# VILLAGE OF LOMBARD REQUEST FOR BOARD OF TRUSTEES ACTION

SPA 04-09: 2020 St. Regis Drive (Yorkbrook Condominiums)

## INTER-DEPARTMENTAL REVIEW GROUP REPORT

<u>SPA 04-09</u>; 2020 St. Regis Drive (Yorkbrook Condominiums): The petitioner is requesting approval of a minor change to the approved planned development for Phases 2 & 3 of the Yorkbrook Condominium development.

# **Exterior View of Existing Phase I Looking Southeast**

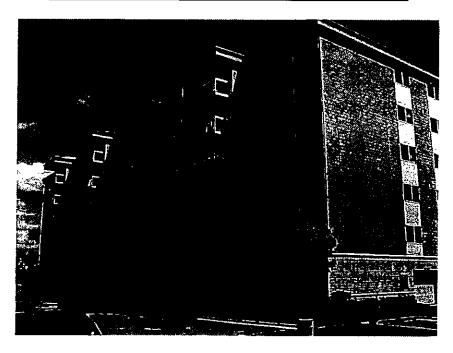
Unlike Phase 1, Phases 2 and 3 are proposed to have a flat roof rather than the pitched roof. Lastly, unlike Phase 1, which included protruding balconies, Phases 2 and 3 are proposed to have balconies that are flush with the building.

Hartz will cover the rooftop of the parking garage with synthetic-turf so that residents may use the outdoor deck as an outdoor sitting area as was originally proposed in the 1996 approval. However, in light of the other enhancements they are proposing to the project, they are looking to amend the approval so that Hartz themselves will not be responsible for the roof landscaping elements.
